UNITED STATES PATENT AND TRADEMARK OFFICE

10/527,462

Laurentius Petrus Joseph Van Loon

Office Action Summary	Application No.	Applicant(s)	
	10/527,462	VAN LOON ET AL.	
	Examiner	Art Unit	
	Janet M. Wilkens	3637

FIG. 5

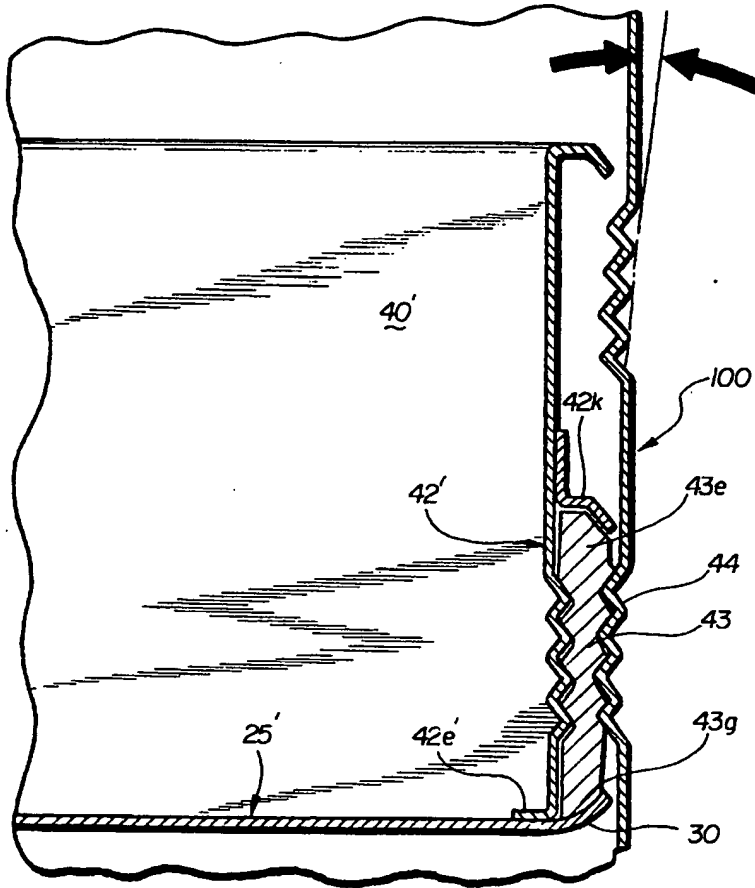
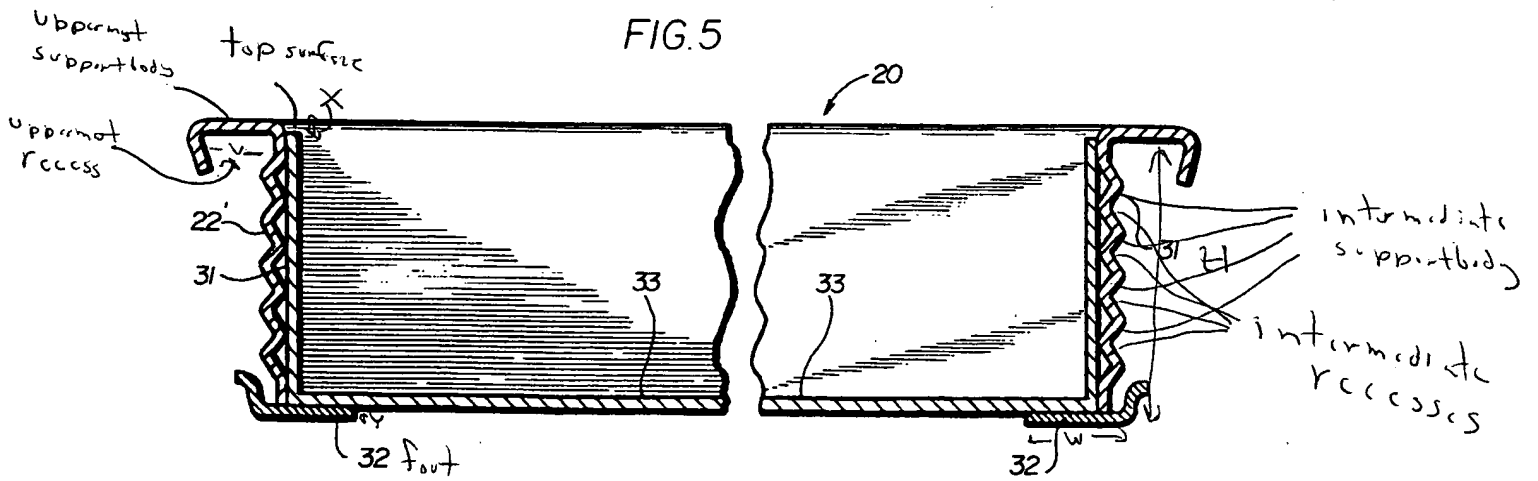
Claims 1, 2, 2/5, 6, 7 and 14-16 are rejected under 35 U.S.C. 102(b) as anticipated by or, in the alternative, under 35 U.S.C. 103(a) as obvious over Krivec (5,549,377). Krivec teaches a drawer (Fig. 5; see Attachment A) which is part of a wheeled cabinet (see Fig. 1) comprising: a bottom surface (33), two side walls (22',31) with a height of H and a horizontal top surface (see Attachment A). The side walls have an uppermost recess that extends the entire side wall, is open toward the outside of the drawer and is delimited from above by an uppermost support body (see Attachment A). The uppermost recesses, viewed in the vertical direction, are a recess distance X away from the top surface and the outside of the uppermost support bodies, view in the horizontal direction, have an external support body spacing V (see Attachment A). A supporting foot (32) extends along the side walls and extends below the bottom surface to a support depth Y (see Attachment A) which appears to be greater than recess distance X. The foot has an internal spacing W which appears to be greater than the spacing V. It should be noted that even if the "greater than" distances discussed above were found not to be accurate (drawings are not necessarily to scale and the compared dimensions are close in size), it would have been obvious to

Attachment B

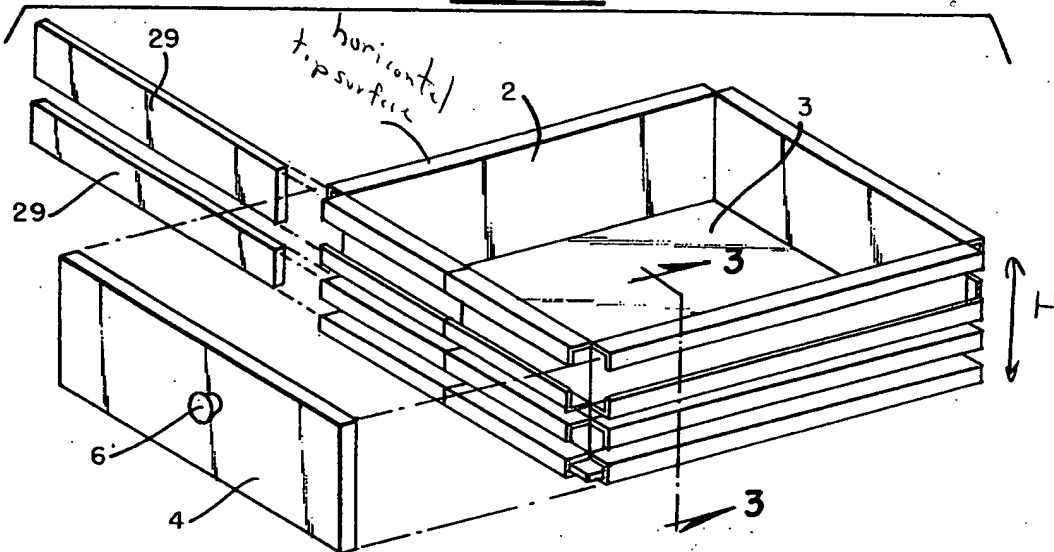
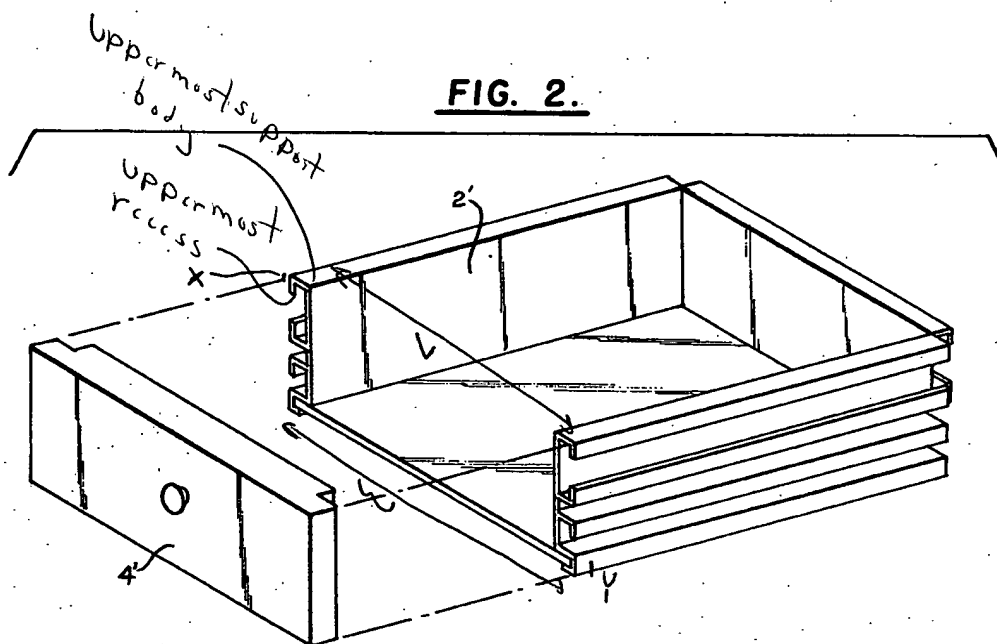
Claims 1, 2, 2/5, 6, 7, and 14-16 are rejected under 35 U.S.C. 102(b) as anticipated by or, in the alternative, under 35 U.S.C. 103(a) as obvious over Ullman Jr. (3,726,579). Ullman teaches a drawer (Figs. 1 and 2; see Attachment B) comprising a bottom surface (3), two side walls (2) with a height of H and a horizontal top surface (see Attachment B). The side walls have an uppermost recess that extends the entire side wall, is open toward the outside of the drawer and is delimited from above by an uppermost support body (see Attachment B). The uppermost recesses, viewed in the vertical direction, are a recess distance X away from the top surface and the outside of the uppermost support bodies, view in the horizontal direction, have an external support body spacing V (see Attachment B). A supporting foot (9a) extends along the side walls and extends

below the bottom surface to a support depth Y (see Attachment B) which appears to be greater than recess distance X. The foot has an internal spacing W which appears to be greater than the spacing V (see Fig. 3). It should be noted that even if the "greater than" distances discussed above were found not to be accurate (drawings are not necessarily to scale and the compared dimensions are close in size), it would have been obvious to dimension the drawer components wherein these limitations would be met. Furthermore, the equation found in claim 2 would inherently be provided for by Ullman. For claim 6, it should be noted that product by process limitations are given no weight in a claim.
